**AUTHORIZATION TO DISCHARGE UNDER THE  
NATIONAL POLLUTANT DISCHARGE ELIMINATION SYSTEM**

**Merrimack Station  
97 River Road  
Bow, NH 03301**

**FACT SHEET**

**The particular provisions of the September 2011 Draft Permit now being reconsidered and revised are the effluent limits and reporting requirements for Outfall 003C at Part I.A.4 and for Outfall 003A at Part I.A.2.** Region 1 has prepared a Revised Draft Permit and this Fact Sheet that includes certain changes to these provisions from the September 30, 2011, Draft Permit. In addition, the Region has compiled the administrative record associated with this action and is making it available for public review either on Region 1's website or in person at Region 1's offices in Boston, MA. The Agency is now seeking comment on the Revised Draft Permit provisions as well as on Region 1's analysis supporting the revisions.

**Figure 2 – Modified FGD Primary Treatment System Process Flow Diagram**

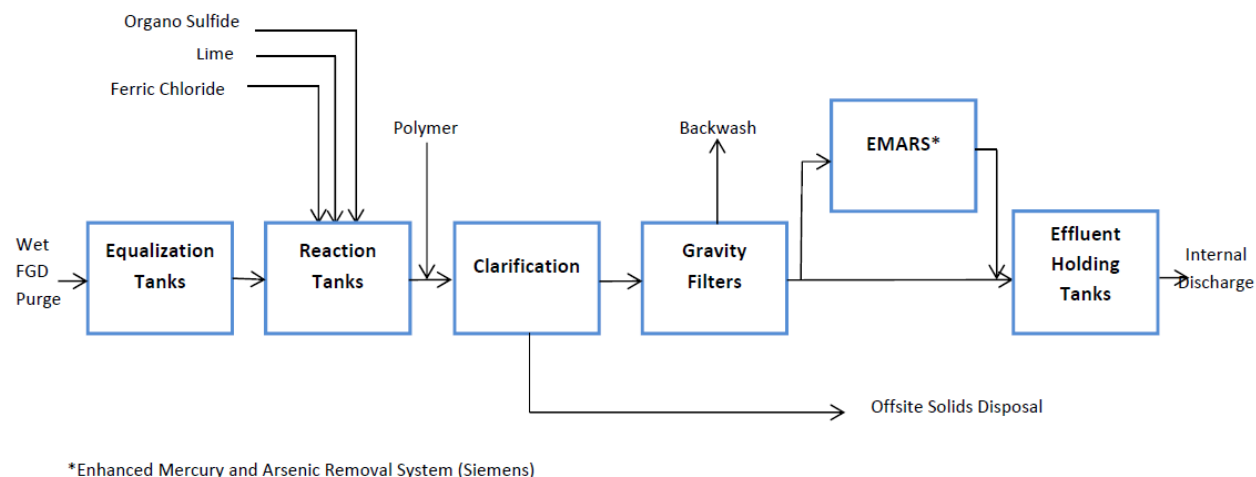
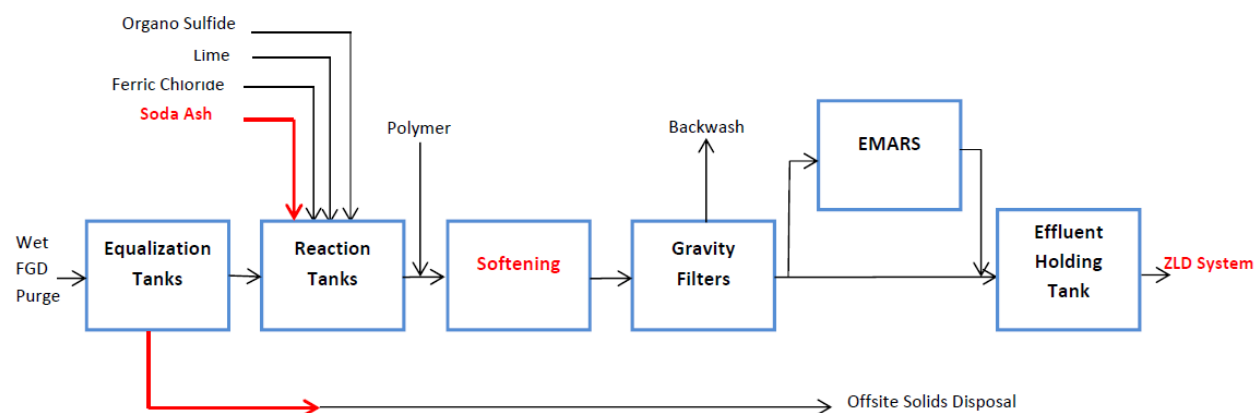
Several minor changes were made to this design with the addition of the secondary treatment system (discussed below), including the addition of soda ash to the reaction tanks and a different holding tank configuration to accommodate pH adjustment in series. Figure 2 shows that the clarifier of the primary treatment system was converted to a lime/soda ash softener. With softening, the predominant calcium chloride salts are replaced with less soluble sodium chloride salts. The resulting solid waste does not contain hygroscopic salts that require special processing to reduce absorption of moisture from the atmosphere. *Id.* See also Sharon DeMeo, Region 1, notes on IWC-13-47 presentation, November 19, 2013.
